**BTRE
FOUR SPEED ELECTRONIC
AUTOMATIC TRANSMISSION
DEALER TRAINING SEMINAR
REVISION IV**

AUGUST 1994

Transmission Plant – Albury

Figure 3 : Sketch of the long planet pinion showing the location and construction details of the groove identifying the new design.

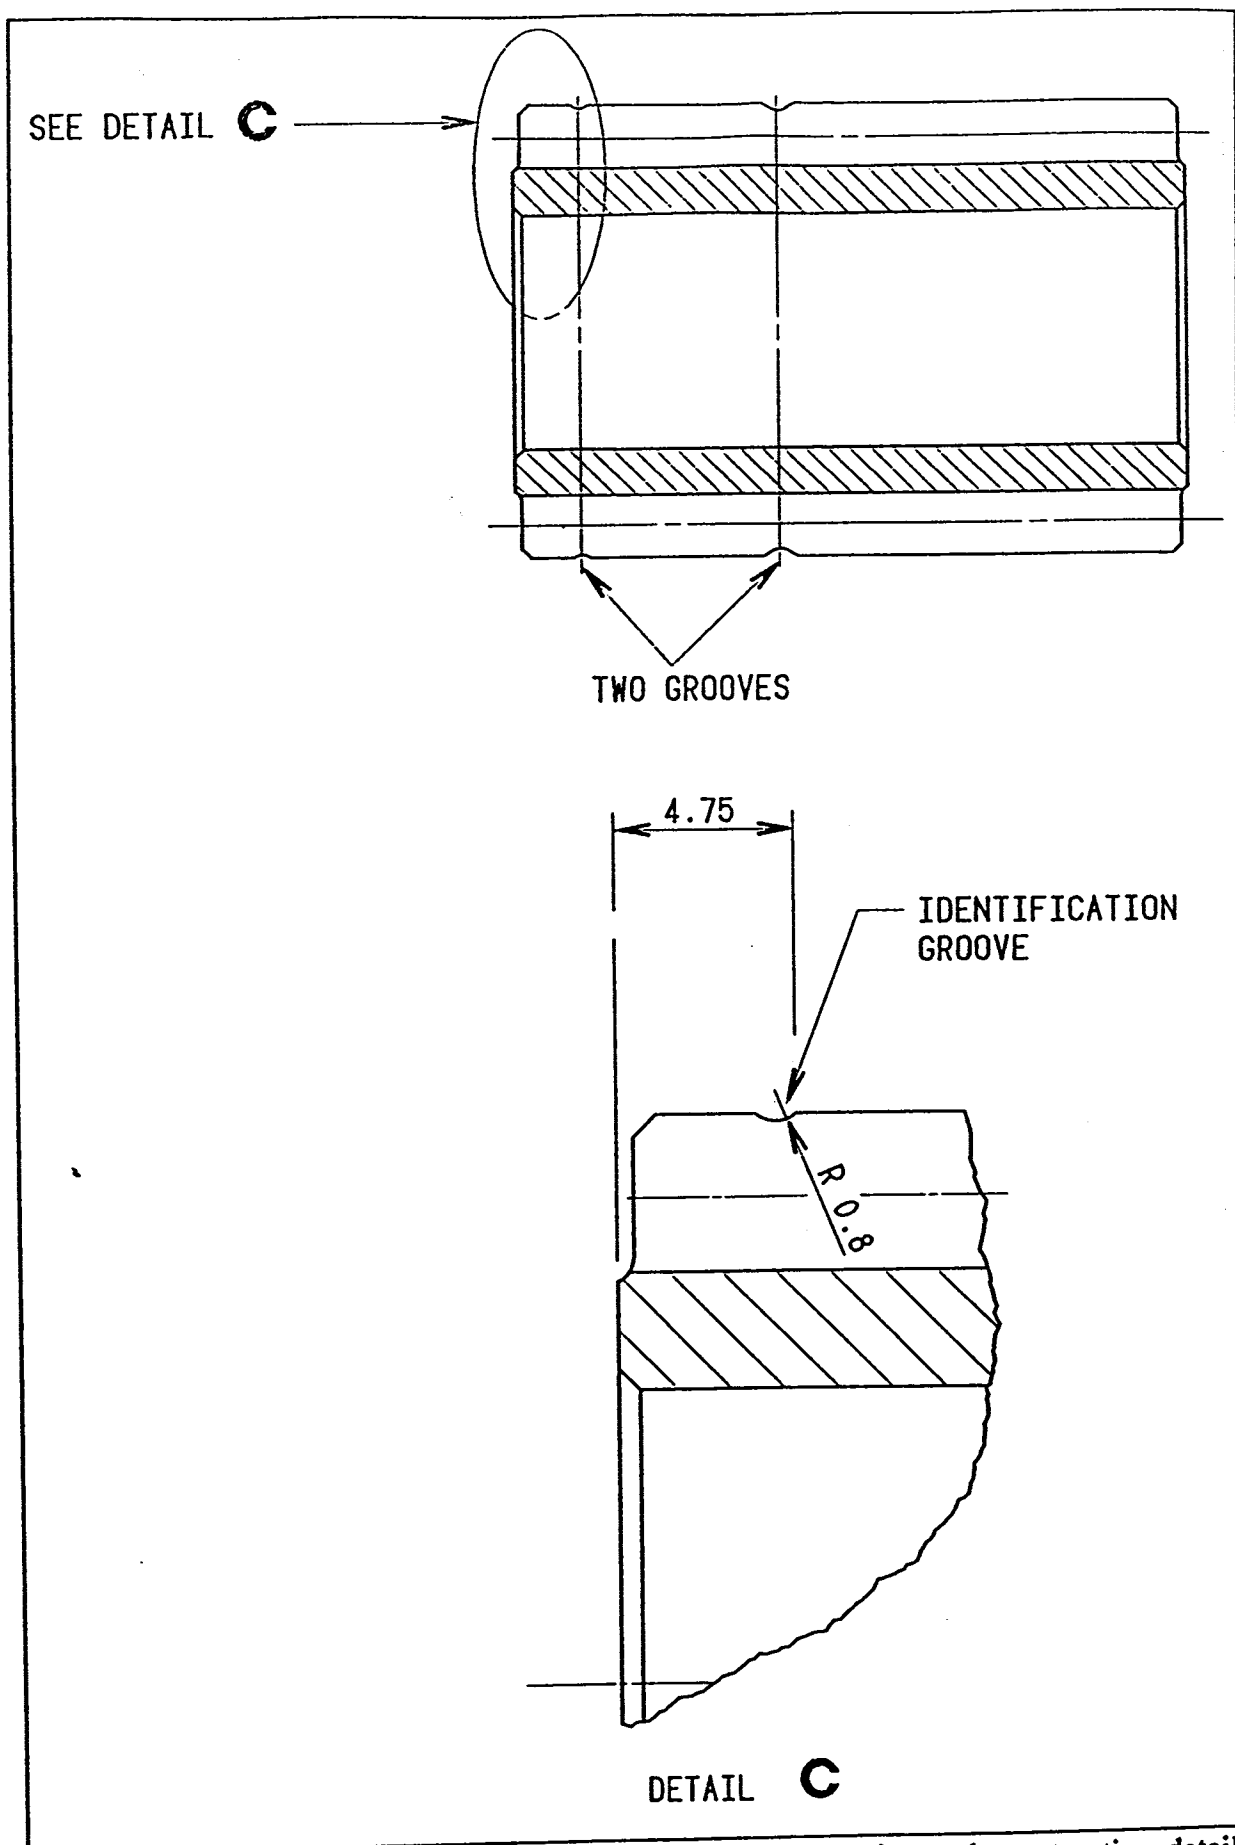
- a. The new long planet pinion has a shallow groove (R 0.8) near an end of the pinion (4.75mm from the end face), refer to Figure 3. This means that the long pinions will have two grooves in total.

Figure 4 : Sketch of the location and construction details of the chamfer identifying the new design ring gear.

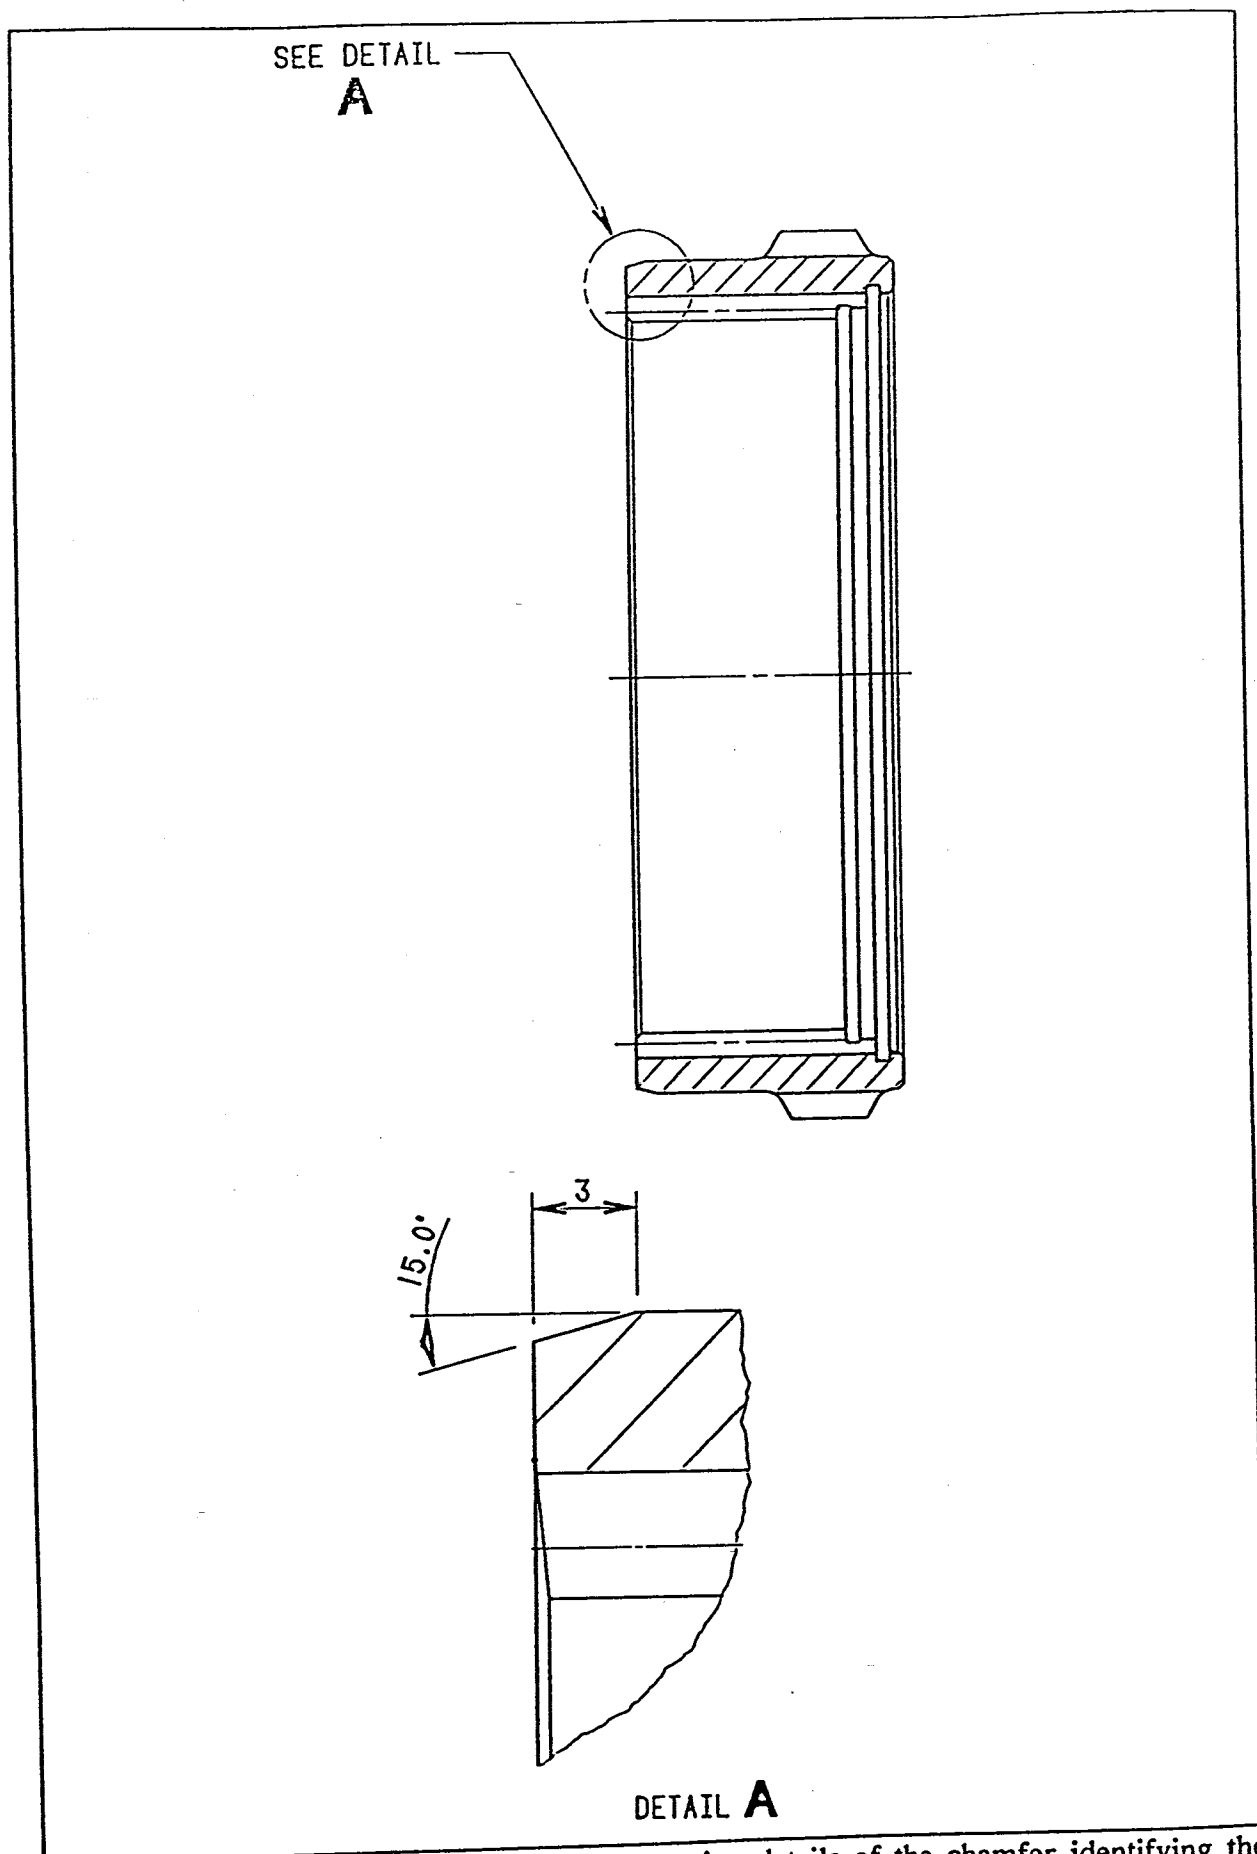
- b. The new ring gear has a large chamfer (3mm x 15°) on the outside diameter in lieu of the former production chamfer (0.8mm x 45°). Refer to Figure 4.
- c. The new output shaft has a radiused groove (R 0.8) in the splines. This groove is 7mm from the end face of the output shaft. Refer to Figure 5.
- d. Short planet pinions are identifiable by their ground outside diameter. Refer to Figure 6.
- e. Planet carrier assemblies featuring the new long and short pinions can be identified by viewing the groove on the long pinion from the open end of the carrier assembly. Refer to Figure 7.
